GE Hitachi Nuclear Energy

MFN 07-597

Subject: **Response to Portion of NRC Request for Additional Information Letter No. 101 Related to ESBWR Design Certification Application - Design of Structures, Components, Equipment, and Systems - RAI Numbers 3.4-10 and 3.4-11**

RAI Numbers 3.4-10 and 3.4-11

Figure 3.4-10 (1) Typical Sketch of Waterproofing at Personnel Access Opening

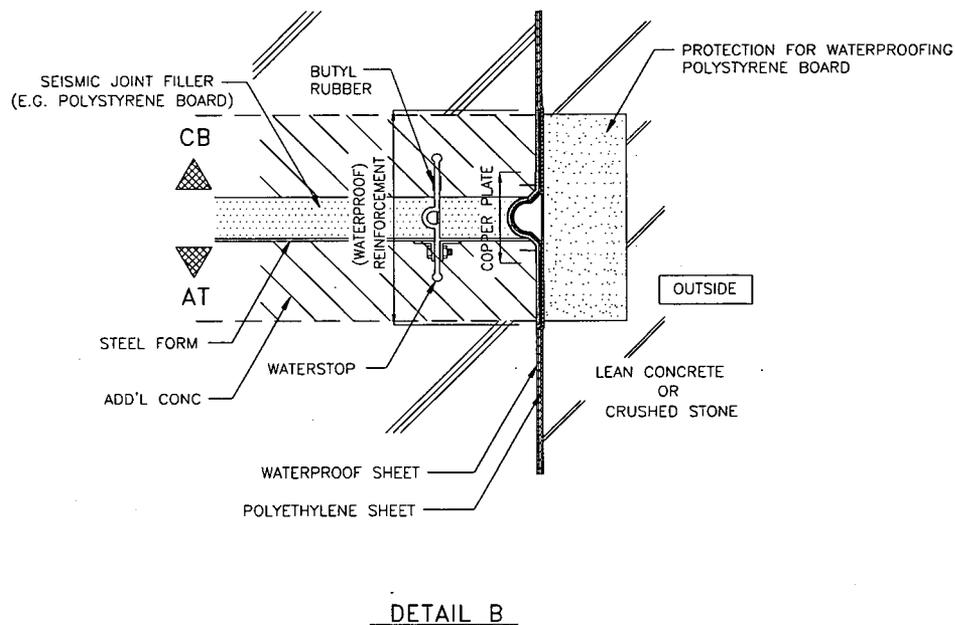
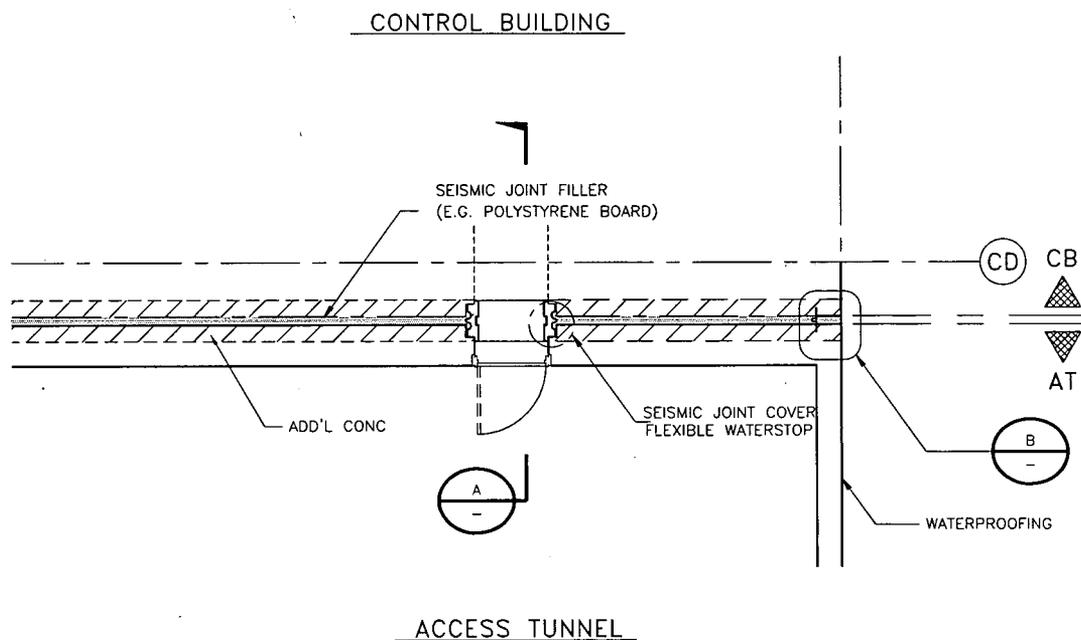
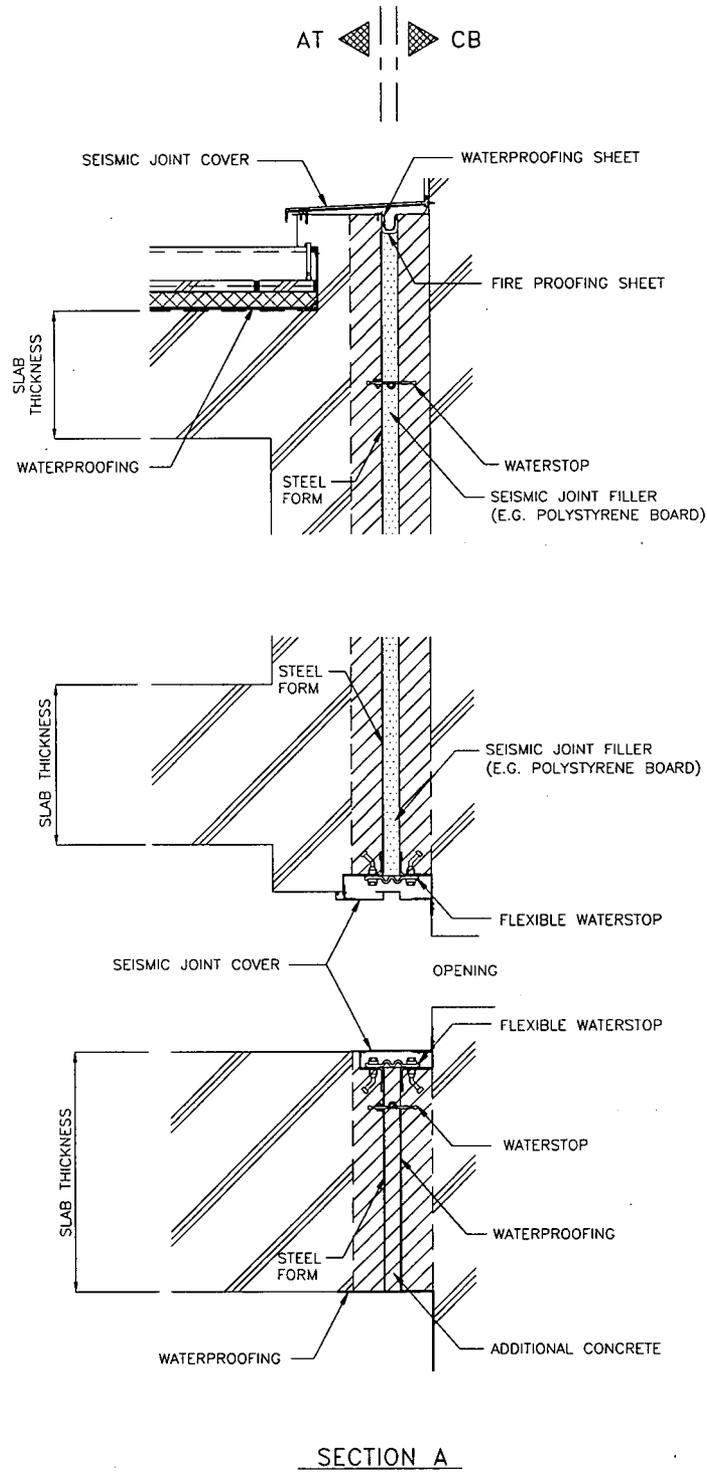
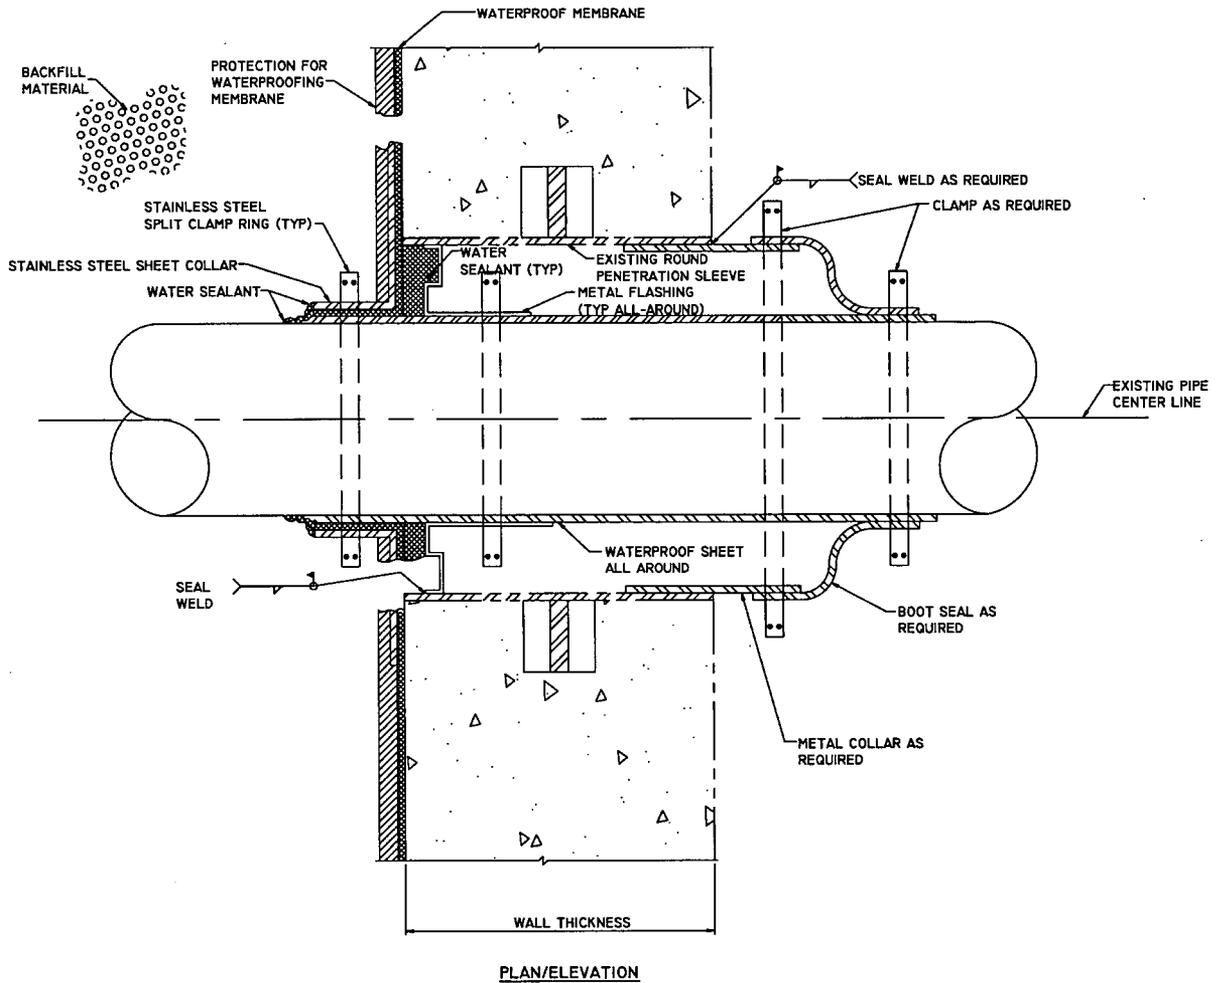
Referring to Table 3.4-1 of the ESBWR DCD Tier 2, Rev. 3, provide a listing of penetrations below design flood level that go through the reactor, fuel and control buildings (including the access opening at control building access to reactor building at tunnel), and typical sketches of the penetrations/access opening depicting how the water-leak tight function of the seals is ensured against the hydrostatic pressure head due to the design flood or ground water. Also indicate if bellows are used for some large diameter penetrations to accommodate for the potential differential displacement effects.

Locations of penetrations below design flood level that go through the reactor, fuel, and control buildings are determined during the detailed design. Personnel Access opening at control building access to reactor building at tunnel is provided in DCD Tier 2, Rev. 4, Figure 1.2-3.

Figure 3.4-10 (1) shows a sketch of the personnel access opening. The water-leak tight function is ensured by the membrane waterproofing applied on exterior concrete surfaces and waterstops installed between two adjoining buildings.

Figure 3.4-11 (1) Comparison of Distributions of Soil Pressures

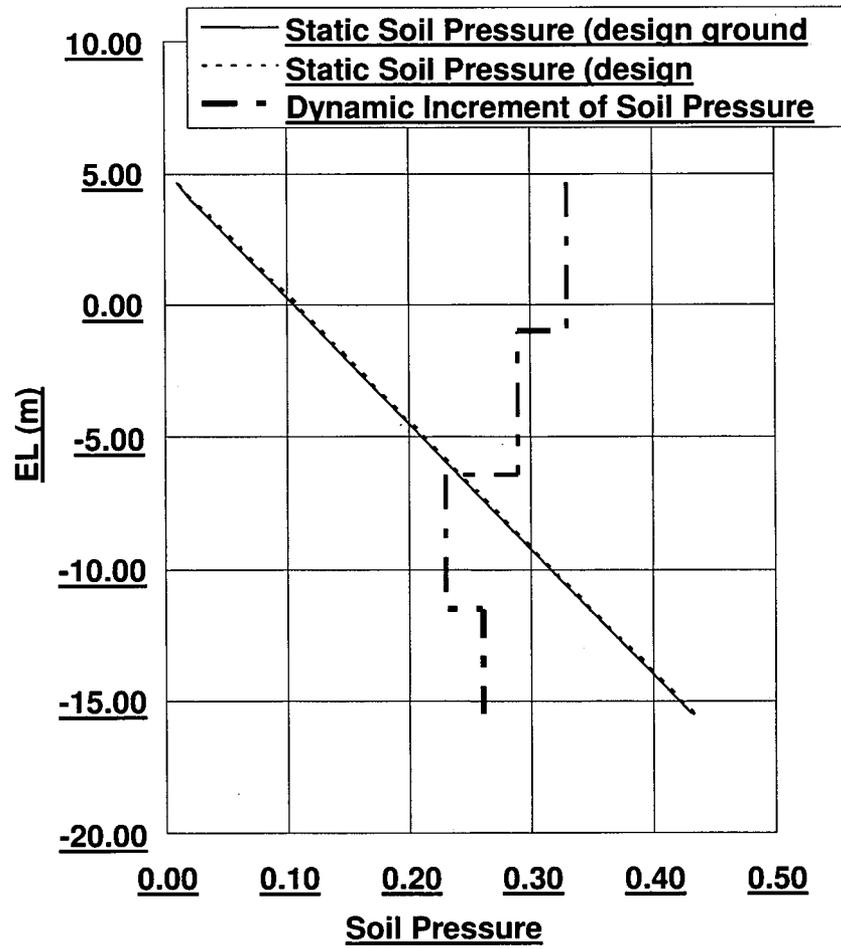
The last paragraph of ESBWR DCD Tier 2, Rev. 3, Section 3.4.2 states that the lateral hydrostatic pressure on the structures due to the design flood level, as well as ground water and soil pressure, are factored into the structural design in accordance with SRP 3.4.2. The paragraph further refers to DCD Tier 2, Appendix 3G, Design Details and Evaluation Results of Seismic Category I Structures, for more specific design information. Provide a discussion of the specific steps adopted in accounting for the lateral hydrostatic pressure due to the design flood level, as well as ground water and soil pressure for the embedded areas of the reactor and fuel buildings including references to pertinent quantitative analysis results of Appendix 3G to DCD Tier 2.

The design flood level is 310 mm (1ft.) higher than design groundwater level. Figure 3.4-11 (1) shows the static soil pressure (including hydrostatic pressures) for the design groundwater level (610 mm (2 ft.) below design plant grade) during the normal operation and design flood level (310 mm (1 ft.) below design plant grade) for flood conditions. The difference between the two conditions is very small. According to Article 9.2.7 of ACI 349-01, to which the design of the Safety-Related concrete structures conforms, the design flood is considered in Nos. 6 or 7 combinations in DCD Tier 2, Rev. 4, Table 3.8-15. In the load combinations including E', dynamic increments of soil pressures need to be considered together with the static soil pressures (including design ground water hydrostatic pressures) during the normal operation. The distribution of the dynamic increment of soil pressure is also indicated in Figure 3.4-11 (1), and its magnitude is much larger than the differences between the static soil pressures during normal operation and flood conditions. Because soil pressures during flood conditions are enveloped by those due to the SSE, they do not govern the design.
